Review: Navigational Risk Options – Terneuzen

Deltares was asked to review the Document *Navigational Risk Options – Terneuzen* prepared by Amentum (Document no: 5060PR0007/FR-001, Revision: 01, 25 November 2025). It concerns an assessment of navigational risks to assist the Ministry of Economic Affairs (EZK) with ongoing technical evaluations for various sites to support the nuclear power program in the Netherlands.

Figure 2.1 Sailing routes in the study area (: <https://vaarweginformatie.nl/>).

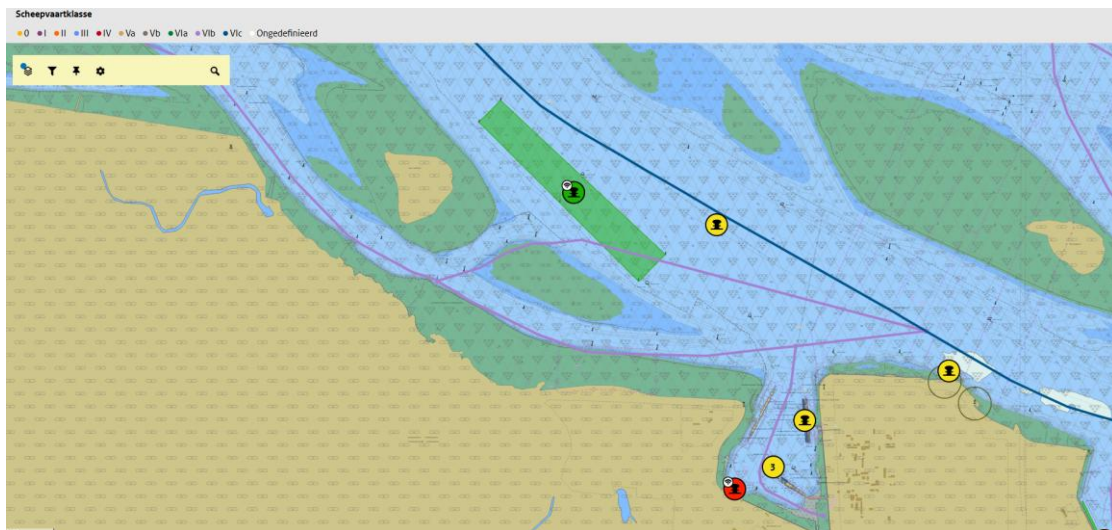
P.11: Section 5.1 Sub-Option A - Edge of Channel:

The intake heads of option 1A are located in the fairway (class VIb) providing access to the Braakmanhaven and the port of Breskens, see Figure 2.1 below (Source: <https://vaarweginformatie.nl/> ). The impact on these navigation routes and accessibility to the port basins should be considered in the evaluation of different layout alternatives.
